**Re: Blackhead Mountain Lodge  
64 Crows Nest Road  
Site Plan/Special Use Permit Application (2022-1101P)**

**Review of**  
**Water Supply Hydrogeologic Report**  
**For**  
**Blackhead Mountain Lodge**  
**Cairo, NY**

Such Report was prepared by  
Sterling Environmental Engineering, PC  
24 Wade Road, Latham, NY 12110  
For Their Client  
RCBG JV Manager, LLC  
50 Beale Street, Suite 2300, San Francisco, CA

Review Prepared by  
Katherine J Beinkafner, Ph.D., NYS P.G. #1176  
Mid-Hudson Geosciences  
1003 Route 44/55, PO Box 32, Clintondale, NY 12515  
(845) 873-7821 [rockdoctor@optonline.net](mailto:rockdoctor@optonline.net)

**Figure 9.29. Interference between adjacent wells tapping the same confined aquifer. Composite cone is for both wells pumping simultaneously under the assumed conditions.**

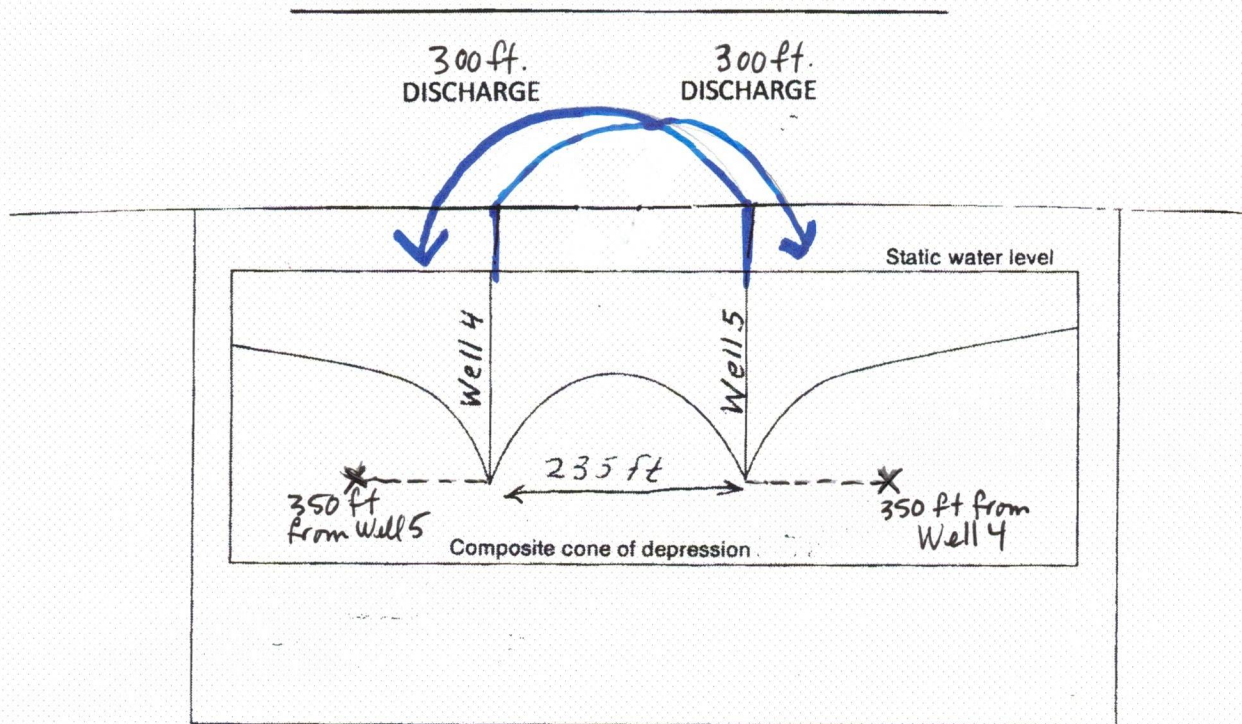
The above procedures are relevant because wells 4 and 5 are only 235 feet apart and therefore share very similar cones of depression in the bedrock (see Attachment B). There is no reason to try to pump both wells simultaneously and expect a combined 64 gallons per minute yield, because the point of discharge of pumped water was only 300 feet from each pumping well during their respective 72-hour pumping tests (November and December 2024). **Sterling only demonstrated that you could keep pumping a well forever at 32 gpm by discharging it back into the cone of depression. That situation describes the concept of recirculation. Discharging 32 gallons per minute into the bedrock cone of depression and continuing to pump 32 gallons per minute out of the same area of the aquifer (Map 2 and Figure 9.29).**

- (5) The close proximity of wells 4 and 5 at only 235 feet of separation is really much too close. A new production well might be drilled into the bedrock aquifer at a distance of perhaps 750 to 1000 feet or more away from wells 4 or 5.

**MAP 2. Blackhead Mountain Lodge Map showing Discharge Locations for Pumping Tests for Well 5 and Well 4. Discharge for Well 5 is north of discharge for Well 4. Discharge points are 300 feet northeast of the pumping wells.**

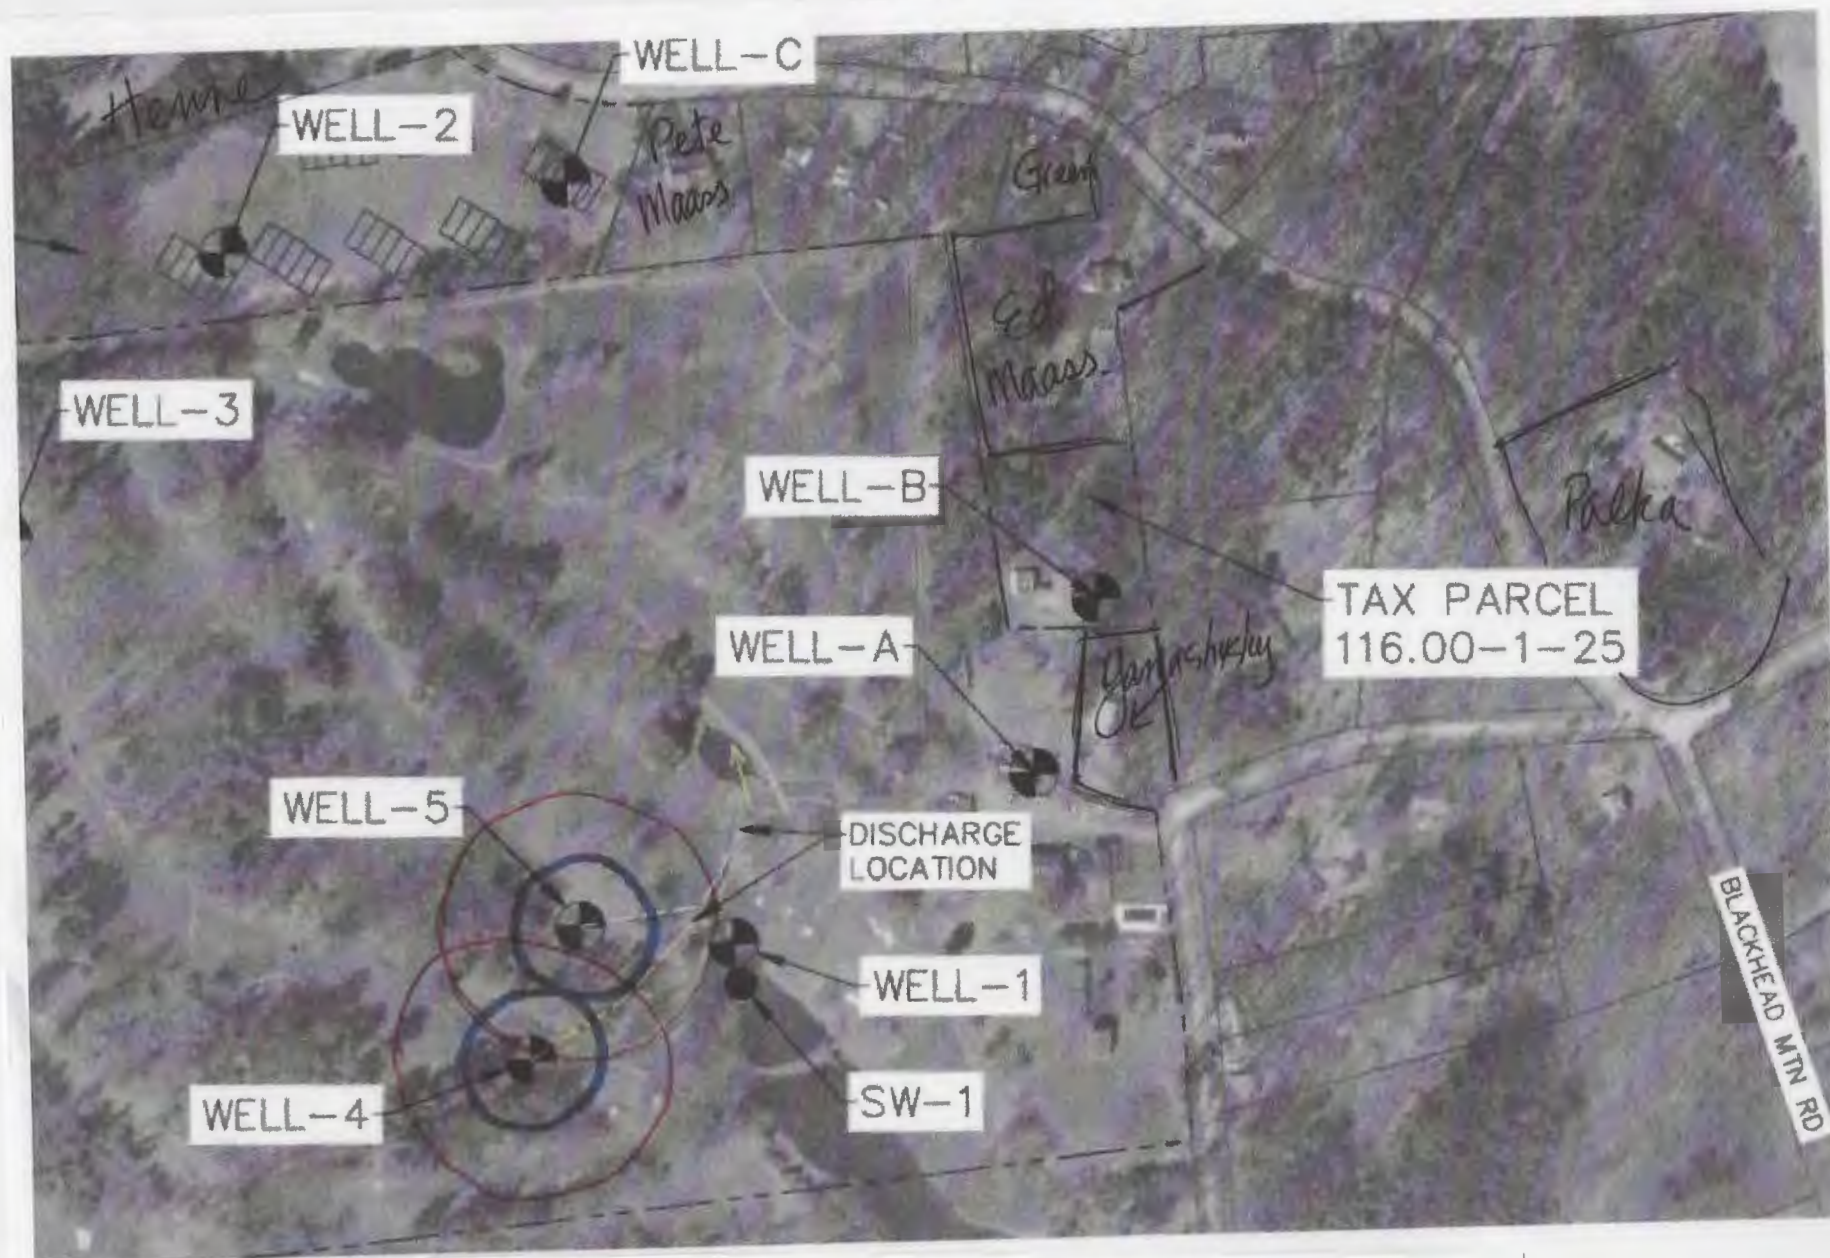
The points of discharge of pumped water from both pumping tests of Well 4 and Well 5 were reported and shown on a map (Map 2) to be 300 feet northeast from the pumping well and not to the south as stated in the Sterling Report (Well 5, page 10; Well 4, page 11). As will be described later with well measurements, both points of discharge were

located within overlapping cones of depression, thus likely causing recirculation of pumped water. This recirculation of water suggests that the wells are not likely capable of producing 32 gallons per minute simultaneously, nor independently. This oversight raises concerns that the pumping tests were not properly conducted and may explain why these wells, even if pumped simultaneously wells 4 and 5 would be inadequate sources of water to provide sufficient yield for the project. The DEC guidance document says discharge should be **at least 300 feet to eliminate recharge into the aquifer.**

For the 72-hour pumping tests of well 5 and well 4, discharge distances of 1300 and 1500 feet down gradient are recommended, respectively based on the distance where observation wells show drawdown and recovery (Table 4 and the November-December 2024 Drawdown Graphs).

MAP 3. Blackhead Mountain Lodge Area showing Area of Discharge and Approximate Cone of Depression for 72-hour Pumping Test of Well 5.

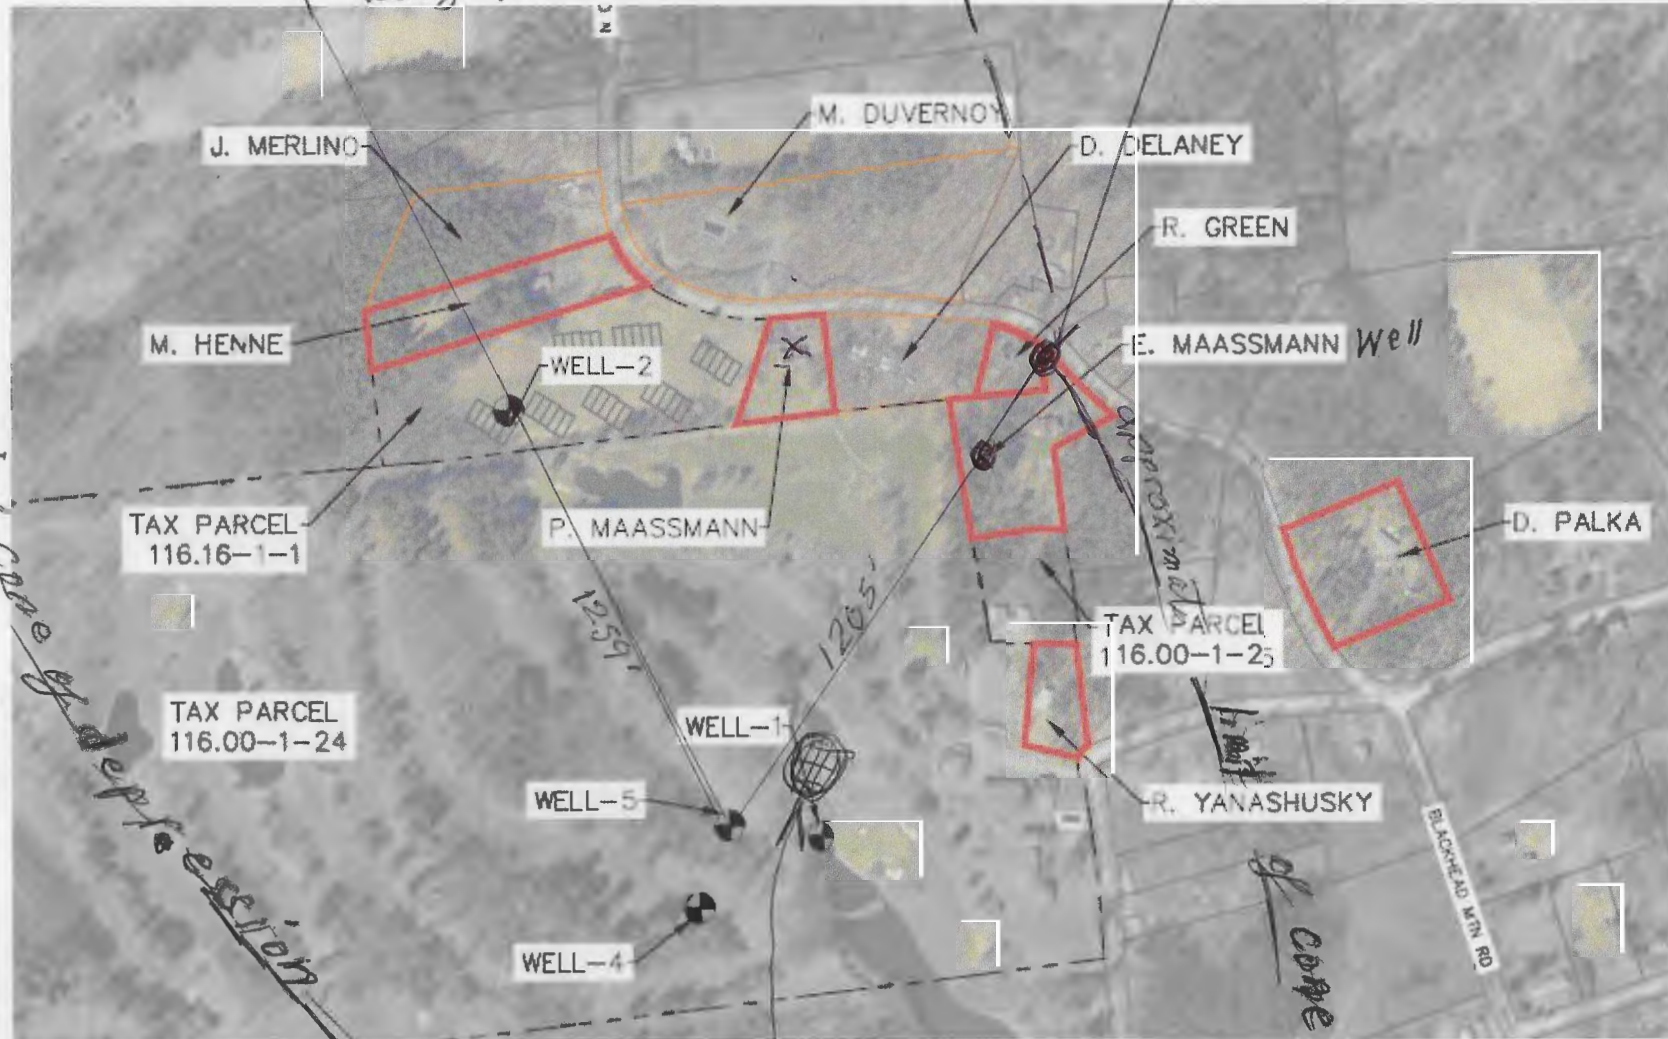
For the well 5 pumping test, two graphs indicated that the cone of depression is likely oval, not circular in shape. Graph 1 indicated a radius of 5460 feet in line from well 5 through well 2. Graph 2 indicated a radius of approximately 1650 to 1900 feet in line with well 5 and E. Maassmann well. The outline of the radius of influence for the cone of depression is shown on Map 3.

Area of Discharge lies within huge cone of depression  
Pumping Well 5 is recirculating pumped water

**MAP 4. Blackhead Mountain Lodge Area showing Area of Discharge & Approximate Cone of Depression for 73-hour Pumping Test of Well 4.**

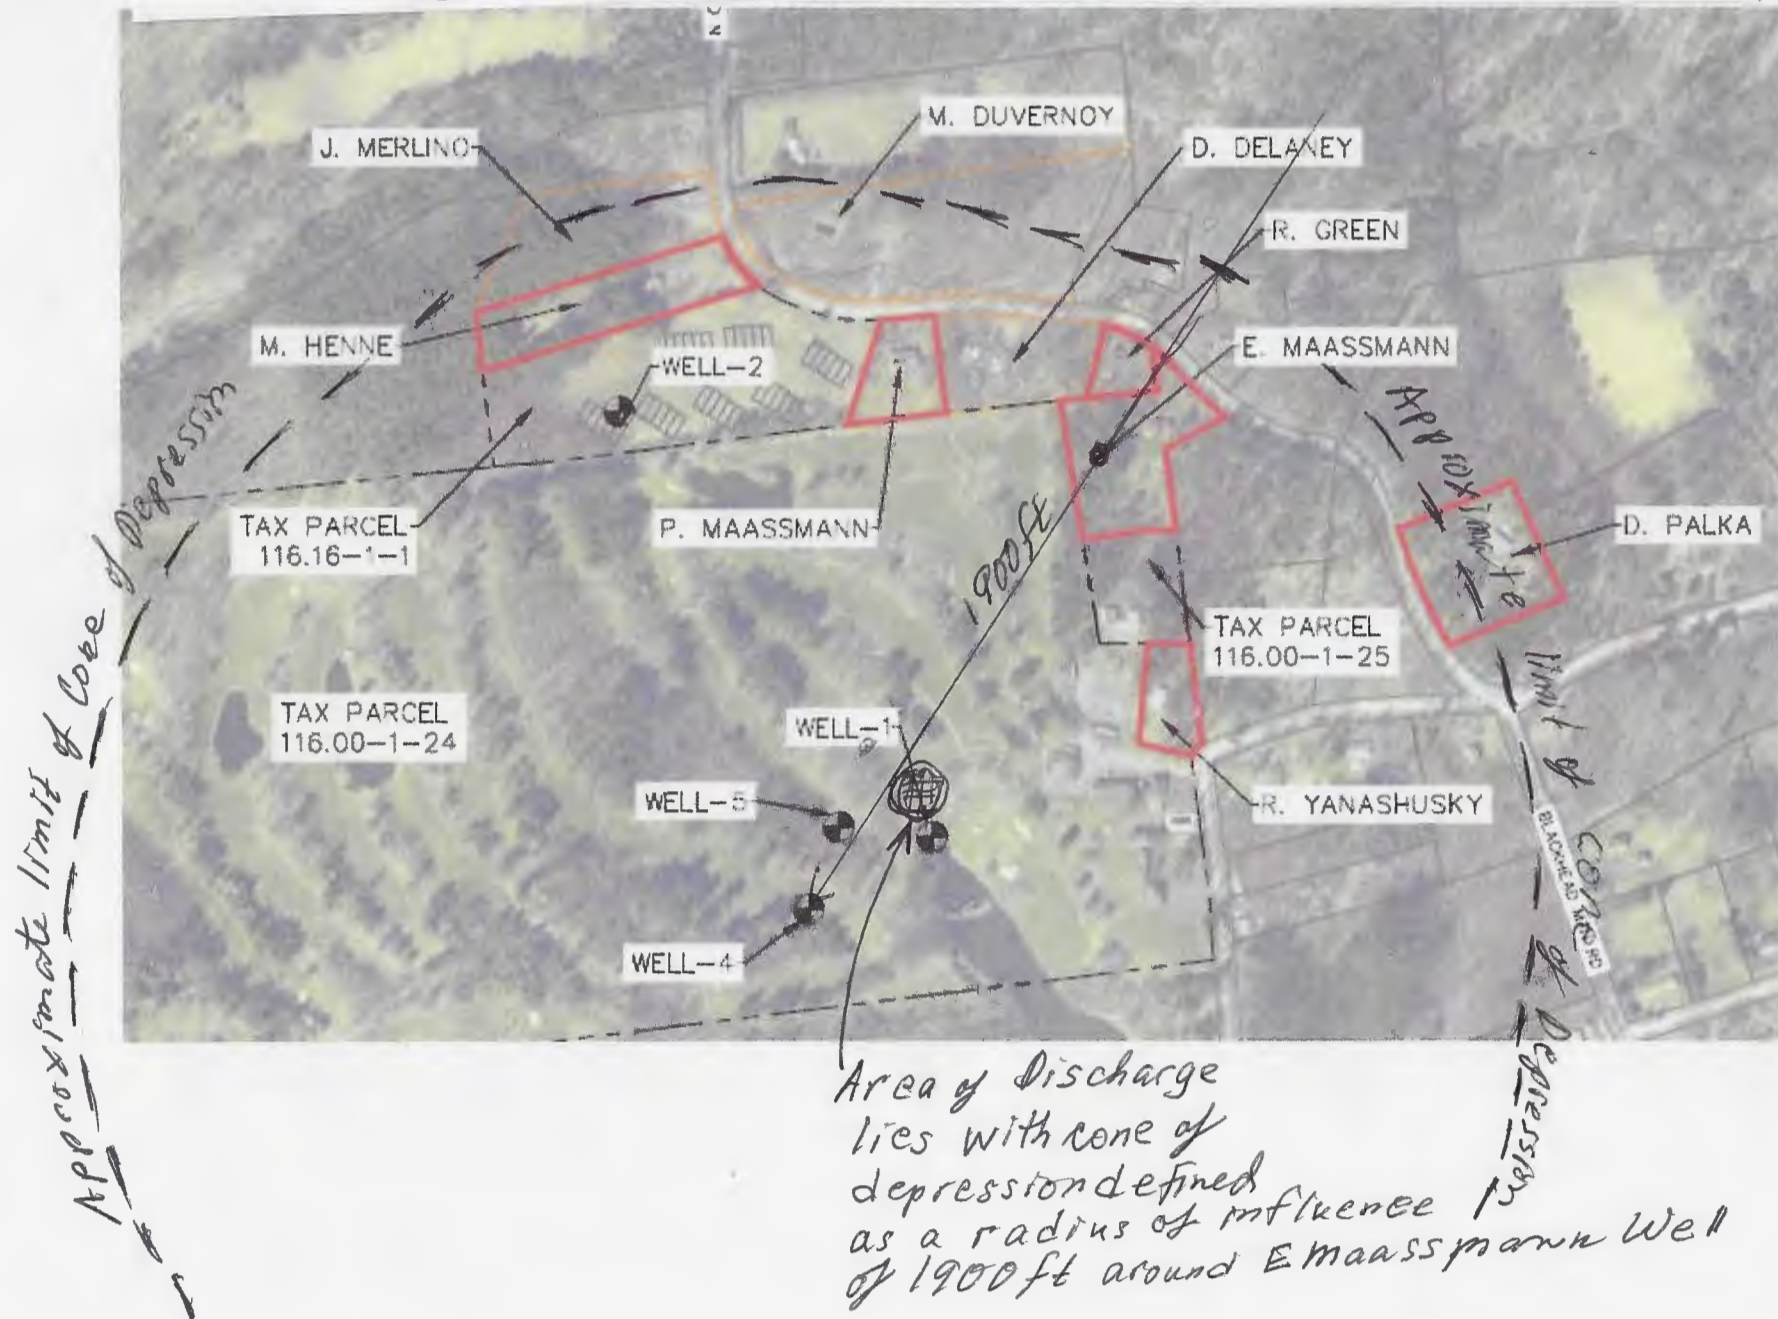
The distance drawdown graph for the well 4 pumping test (Graph 3) also indicated an oval cone of depression, 1800 to 1900 foot radius in line with well 4 and E. Maassmann well and 600 foot radius in line with wells 4 and 5. The 600 foot radius did not seem to fit with the model. A circular radius of 1900 feet was drawn on Map 4.

C) which operated under a SPDES Permit that expired in 2015 (#NY0241857). From map review, one would find this off-site septic system falls within the overlapping cones of depression for both Well 5 and Well 4 and poses an enormous environmental risk to the future water supply in the form of leaching contaminants into the water drawn from these wells (Map 5). In other words, contaminants from the former leach field could be in the water pumped from Wells 4 and 5. If Sterling had conducted the laboratory testing required by NYS DEC in the pumping test guidance document (Attachment A, section 12), this potential life-threatening situation would have been identified by the laboratory analytical work (Table 3).

Green patch  
→ location of  
BTHML off-site  
leach field  
★ within the cone  
of depression

R. Yanashusky Observation Well Hydrograph

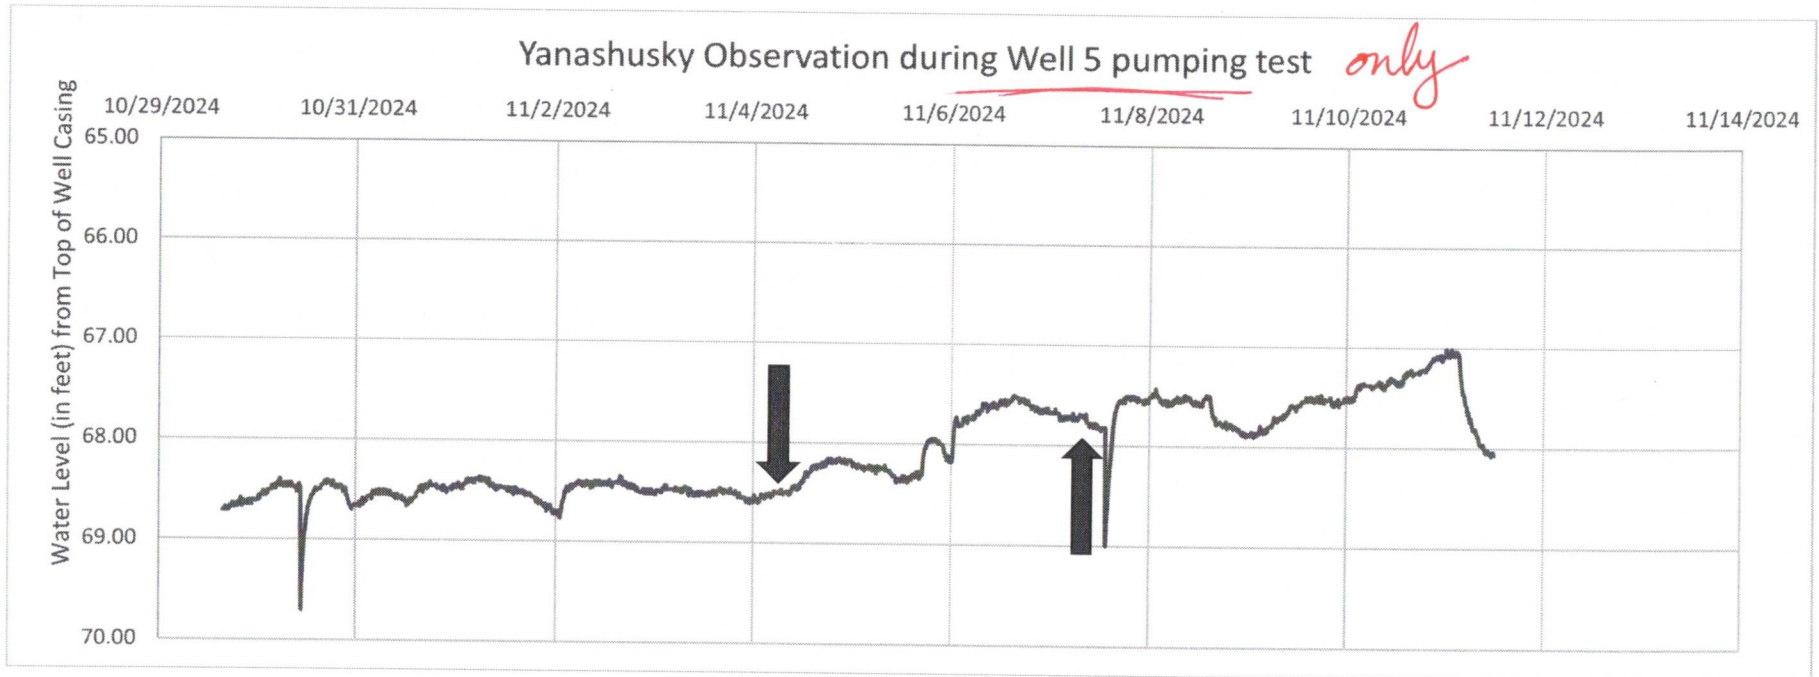
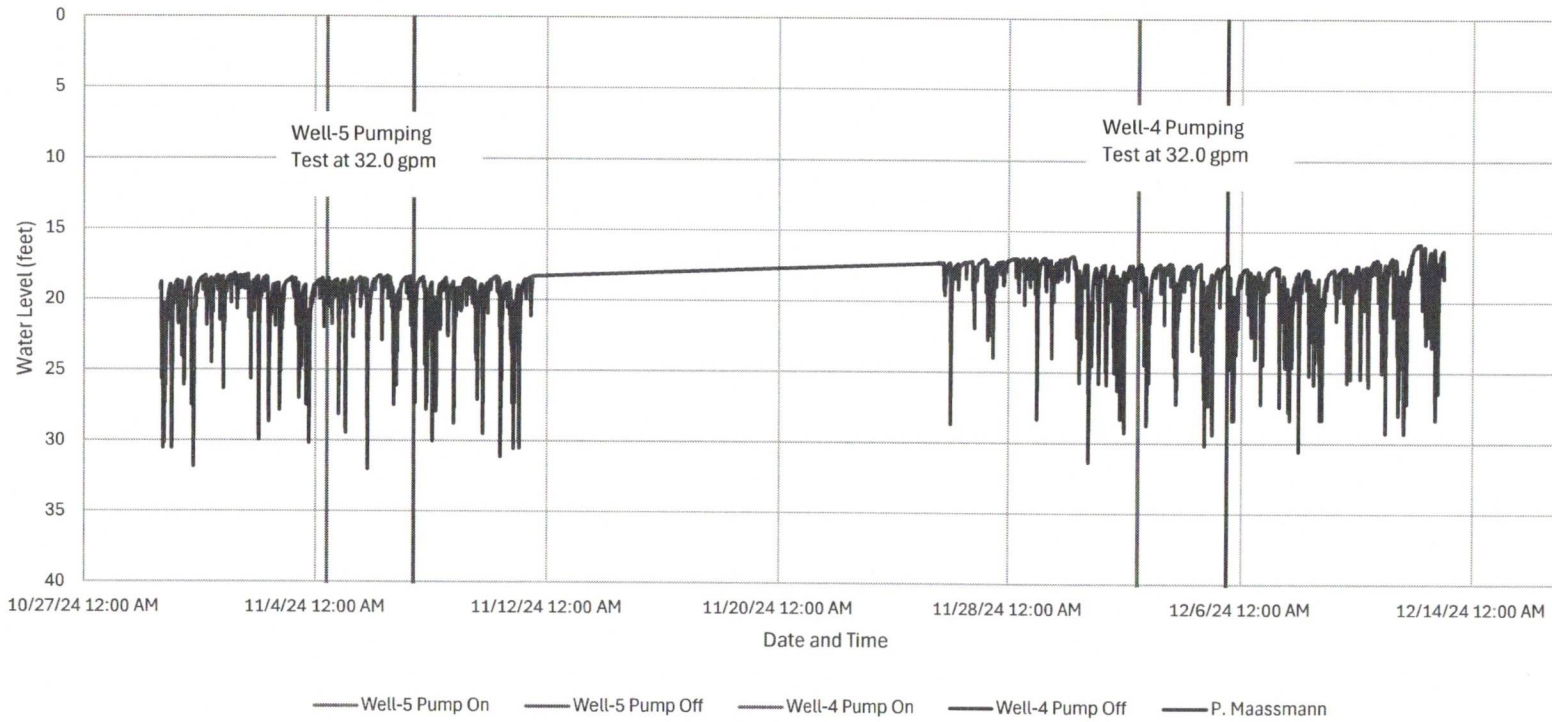
72 hours after the pumping of Well 5 stopped, the Yanashusky Well water level was 67.38 ft. **NOTE:** The sharp fluctuations indicate water usage. **Although the Sterling Report reported that the continuous pumping of Well 5 has no impact on the Yanashusky Well (p 10/524), they fail to comment on the upward slope of its recovery trendline. This trendline indicates a higher water recovery rate than drawdown rate, caused when water pumped out of Well 5 was discharged too close to the aquifer supplying this observation well. In other words, the Yanashusky Well recharging behavior was aided by water pumped out of Well 5, within the cone of depression.**

The same upward recovery trend was observed during the pumping test of Well 4 (December 2–5, 2024). When pumping started, the water level was 67.00 ft. from the top of the well casing. When pumping stopped, the water level was 66.22 ft. from the top of the well casing; an increase of 0.78 ft.
